**ZONING AMENDMENT,
& SUBDIVISION STAFF REPORT**

<u>APPLICANT NAME</u>	Anil Badve
<u>SUBDIVISION NAME</u>	H.S. Norden Place Subdivision, Resubdivision of Lots 2 & 3
<u>LOCATION</u>	1016 Hillcrest Road (West side of Hillcrest Road, 470' ± South of Wall Street)
<u>CITY COUNCIL DISTRICT</u>	District 6
<u>PRESENT ZONING</u>	B-2, Neighborhood Business and B-3, Community Business
<u>PROPOSED ZONING</u>	B-3, Community Business
<u>AREA OF PROPERTY</u>	1 Lot / 1.2± Acres
<u>CONTEMPLATED USE</u>	<p>Subdivision approval to combine two legal lots of record into one lot and Rezoning from B-2, Neighborhood Business District, and B-3, Community Business District, to B-3, Community Business District, to amend the condition of a previous rezoning to allow visitation at an existing funeral home and allow funeral home parking expansion.</p> <p>It should be noted, however, that any use permitted in the proposed district would be allowed at this location if the zoning is changed. Furthermore, the Planning Commission may consider zoning classifications other than that sought by the applicant for this property.</p>

<u>REASON FOR REZONING</u>	To amend the condition of a previous rezoning to allow visita

SITE PLAN

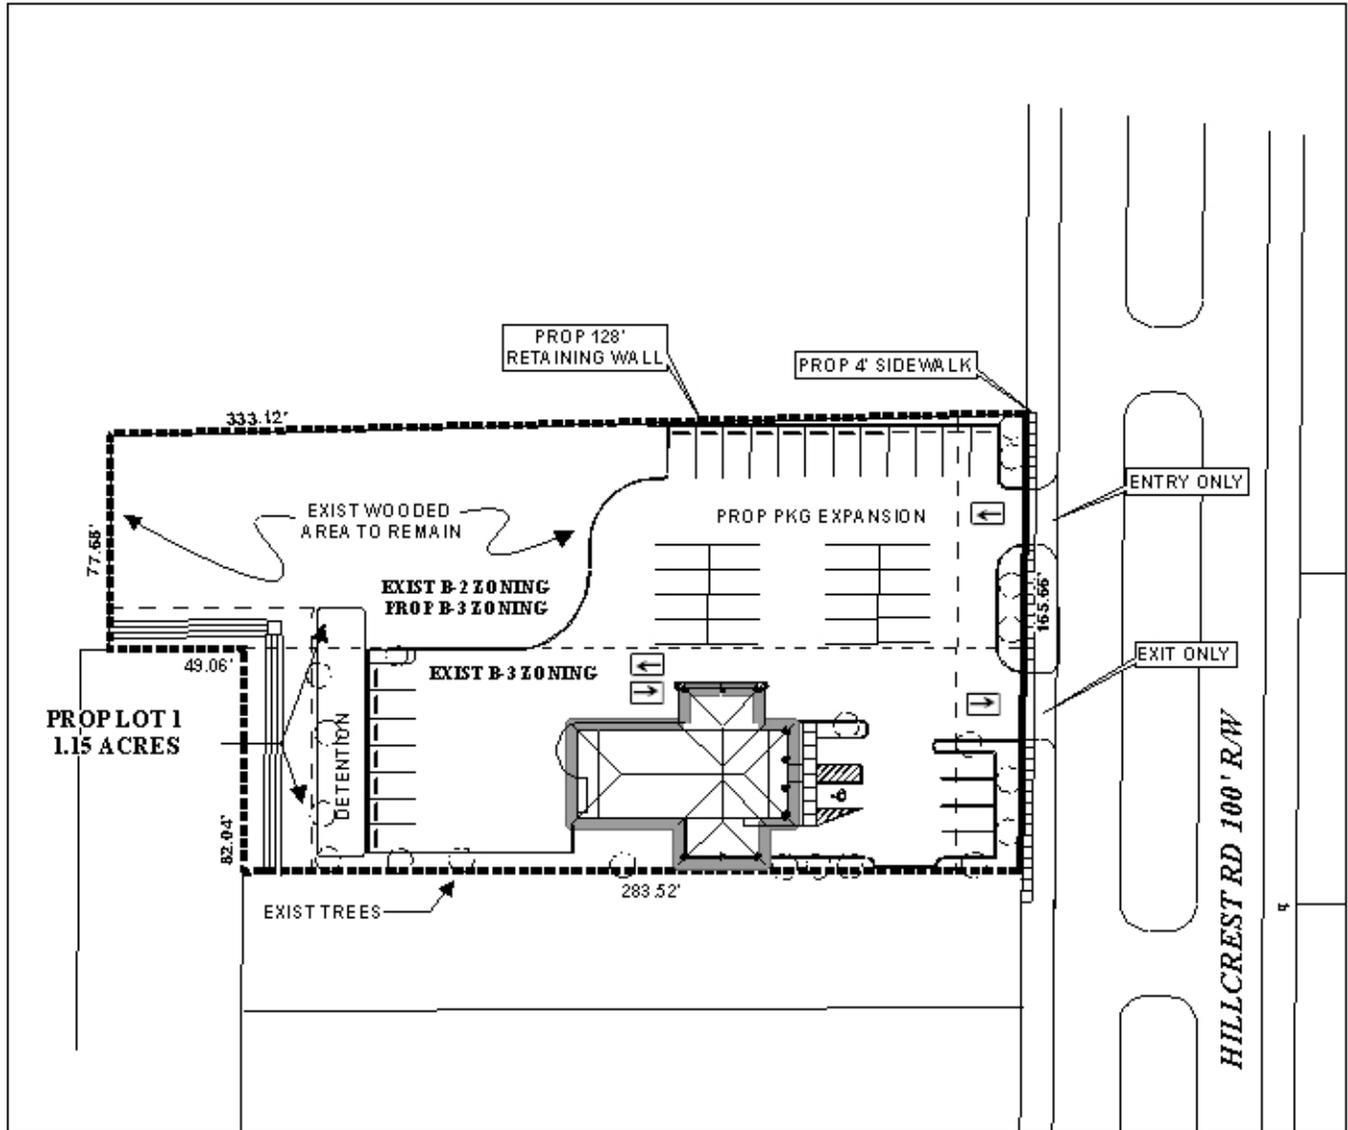
There is no depiction of a buffer where the site abuts residentially zoned property to the West. One condition of the previous rezoning was that the wooded area on the Western portion of the site be left undisturbed as a natural buffer from the adjacent residentially zoned property. However, as illustrated on the site plan, a portion of this natural buffer is to be removed to accommodate storm-water detention. Therefore, while a privacy fence was not necessary in the past, one will be required, if approved as requested.

The site plan illustrates the proposed parking lot expansion onto the currently vacant Northern lot with a total of 42 parking spaces for the over-all site. There appears to be adequate parking for the proposed use; however, the parking ratio used is one per 300 square feet of gross floor. The applicant should revise the site plan to provide information specifying the ratio of office to

visitation use. Office use requires one parking space for every 300 square feet of gross floor area, whereas the visitation aspect will require one space for every four seats, based upon maximum Building Code seating capacity.

As already mentioned, the applicant is proposing two one-way curb cuts. There are two issues with this proposal:

- 1) typically, sites with less than 200' of road frontage are limited to one curb cut (this site has approximately 166' of frontage); and
- 2) the width of the proposed cuts, along with the design of the proposed parking lot, do not support one-way circulation. Typical one-way drives are between 12 and 16' in width, rather than 24' as proposed, and parking lots are designed (angled and painted with arrows) in such a way as to discourage two-way traffic.

Given the fact that the applicant is combining two existing legal lots (currently being allowed one curb cut each), along with the potential traffic volume associated with funeral visitation, the applicant should revise the site plan to comply with the condition of the approved 2008 rezoning requiring both drive entrances to be narrowed to between fourteen and sixteen feet to prevent two-way traffic.

It should be noted that the site plan, as proposed, does not meet the minimum requirements of Zoning Ordinance with regard to trees/landscaping. Of the 1.15 acres (50,094 square feet), 12 percent (6,011 square feet) shall be landscaped; 60 percent (3,607 square feet) of this requirement shall be located on the building site between the street line and the building wall facing the street. The front setback shall have one over-story tree for every 30' of road frontage. There should also be a tree for every 30' of perimeter (no more than one half of the perimeter trees may be under-story). Furthermore, any existing trees for which the applicant wishes to receive credit must be labeled with type and size on the site plan.

No dumpster is indicated on the site plan. The site plan should either be revised to show a compliant dumpster or a note should be placed on the site plan stating that no dumpster will be utilized on the site.

- 1) completion of the Subdivision process;
- 2) provision of a 6' high privacy fence, in compliance with Section 64-4.D. of the Zoning Ordinance, where the site abuts residentially zoned property to the West;

- 3) revision of the site plan to comply with the requirements of the Zoning Ordinance;
- 4) compliance with Traffic Engineering comments: *(Driveway number, size, location, and design to be approved by Traffic Engineering and conform to AASHTO standards. Narrow driveway widths to sixteen feet or less and improve the radii to twenty feet. Sign and mark the driveways as one-way. An abbreviated traffic impact study is required for this development.)*;

- 5) revision of the site plan to either show a compliant dumpster or the placement of a note on the site plan stating that no dumpster will be utilized on the site;
